17 February 2017

DEXUS QUARRYWEST PROJECT (SSD 6801) – SECTION 96 MODIFICATION (MOD 3) – STATEMENT OF ENVIRONMENTAL EFFECTS

Figure 4: QuarryWEST Precinct B Site Plan – As Proposed

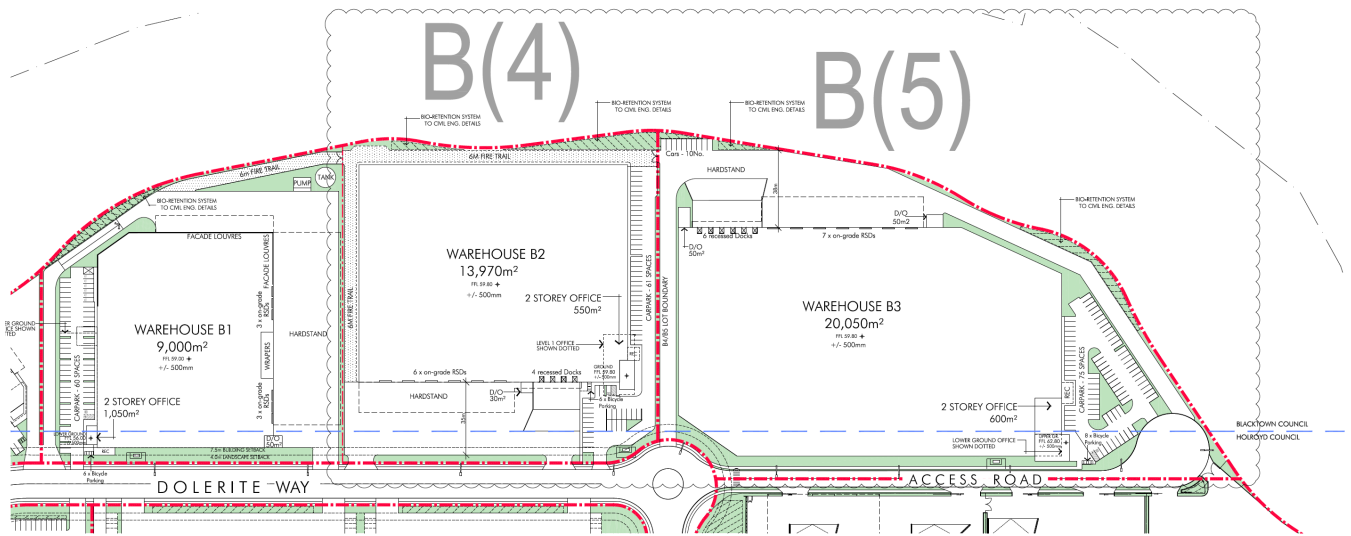
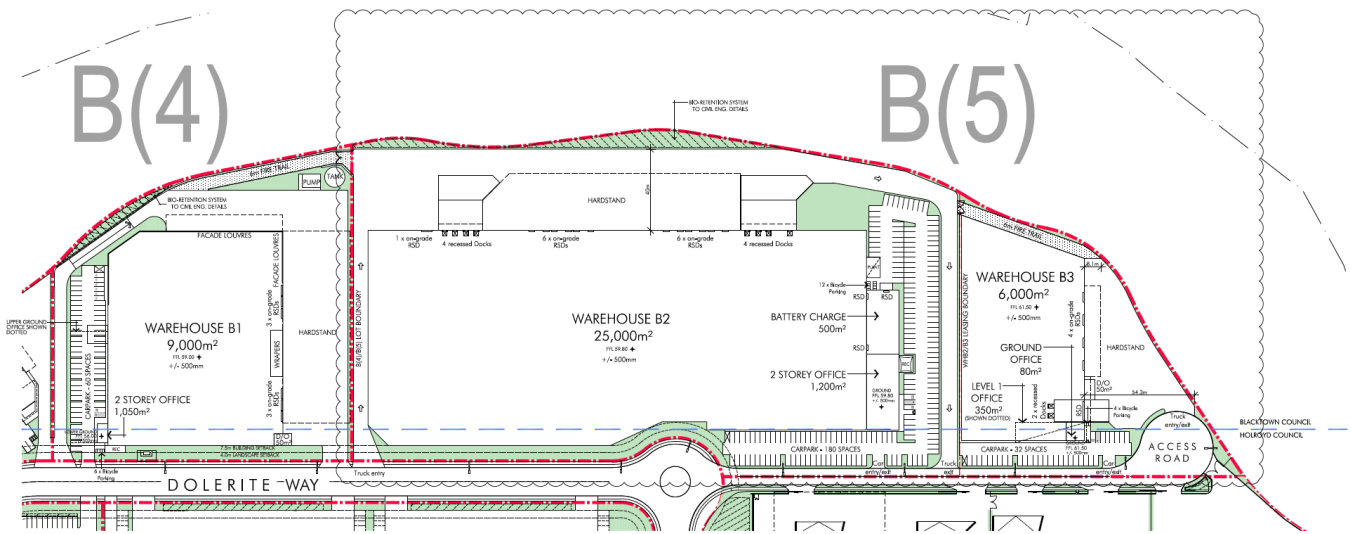
DEXUS proposes to modify the development consent for the QuarryWEST Project to amend the internal masterplan layout in Precinct B. The changes involve alterations to the layout of Warehouse B2 and Warehouse B3, including:

- amendments to the footprint and layout of the lots and facilities, including ancillary offices;
- an increase in the floor area of Warehouse B2, and a decrease in the floor area of Warehouse B3;
- an increase in the building height of Warehouse B2 (to 17.4 metres); and
- changes to accesses, internal circulation and parking layout.

Figure 5: Warehouse B2 Eastern Elevation – As Proposed

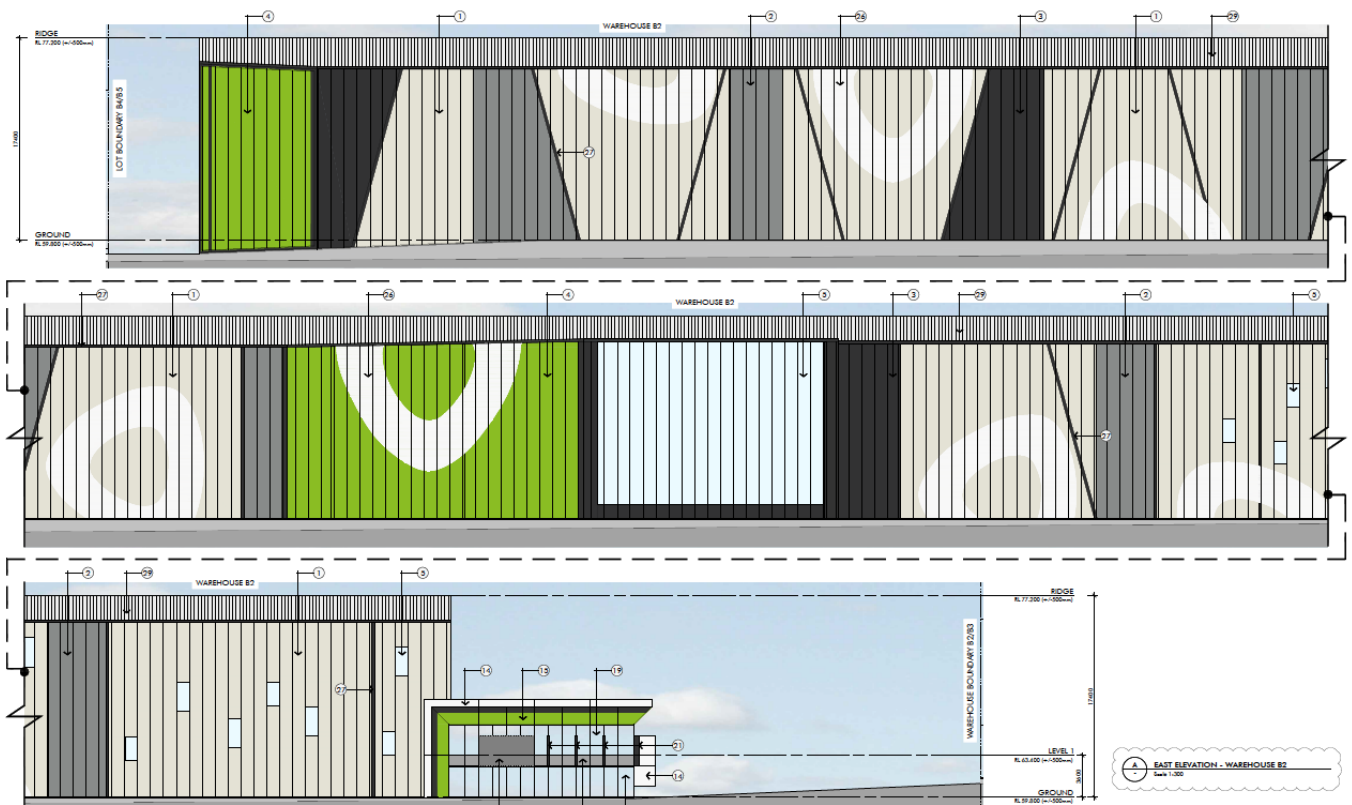
As outlined in the above table, the proposed modified masterplan complies with all of the development standards in the SEPP, apart from building height for one building (Warehouse B2) located within the IN2 zone. Warehouse B2 is proposed to be increased to a maximum ridge height of 17.4 metres, which is some 2.4 metres above the 15 metre development standard. It is noted that the height of the building at the eaves of the eastern elevation would be approximately 14.9 metres, which complies with the development standard.

- the Warehouse B2 facility, and in particular the eastern façade, has been designed to a very high standard with a range of materials, colours, design elements and articulation. This would assist in minimising the scale and bulk of the facility, and provide visual interest and relief (see Section 4 below for further detail);
